DEVELOPMENT REVIEW BOARD - **HYDROLOGY SECTION**

DRB Project Number: 2021-006297 Hearing Date: **6-22-2022**

Project: Tracts 469 & 470 Lands of Atrisco Land Grant-7300 Santa Barbara Agenda Item No: **8**

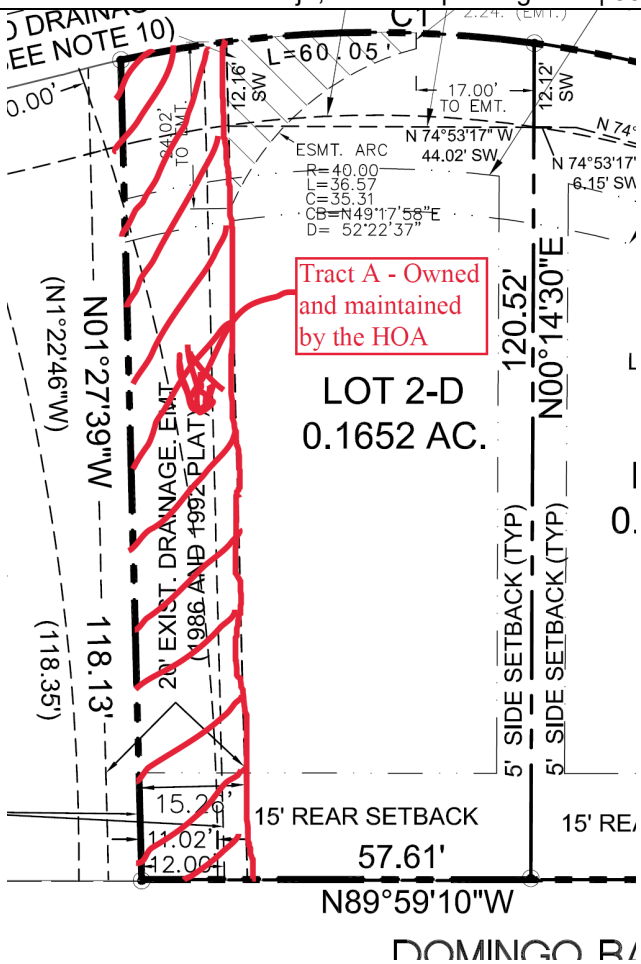
- Hydrology sent a comment letter (D19D001F) on May 09, 2022.
- Hydrology did get a resubmittal on June 13, 2022. **Hydrology recommends a four week deferral.**
- The existing drainage easement shown as part of Lot 2-D should be on its own tract to be owned and maintained by the HOA.

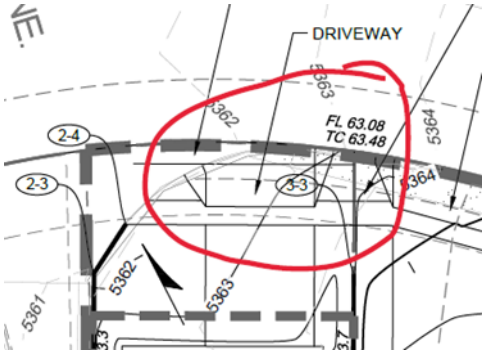
- Typically, the drive pad cannot be built on a radius. Please consult Transportation Section.

This problem can be solved with extending the curb & gutter along the property line and then have a smaller radius after the drive pad as shown below.
